Subject	▶ Change of Lock Plate for Change Lever
For Models	▶ DA4031
Country	▶ All countries
Description	▶ Lock Plate for Change Lever has been replaced by Retaining Ring. See below for the details.

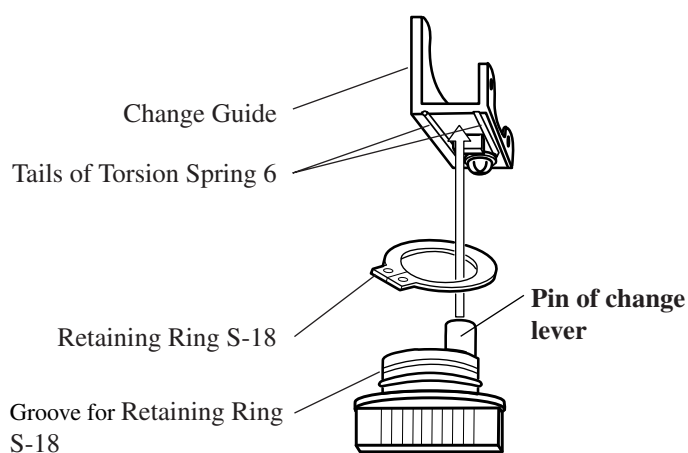
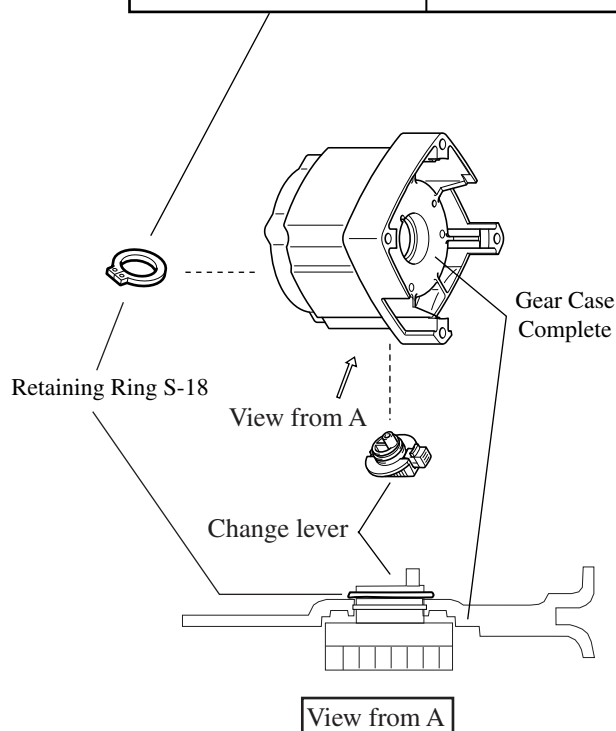
▶ Current	▶ New
Lock Plate (345190-5)	Retaining Ring S-18 (961078-7)

- 1, Insert Change Lever so that its Pin can be installed between the tails of Torsion Spring 6 through inside of the Retaining Ring S-18 as illustrated above.
- 2, Attach Retaining Ring S-18 to the groove of the Change Lever with retaining ring pliers. See the illustration to the left.

Item No.	Current part		Q'ty	I/C	New part		Q'ty	Note
040	Lock Plate 345190-5		1	←	Retaining Ring S-18 961078-7		1

From December 2002 production
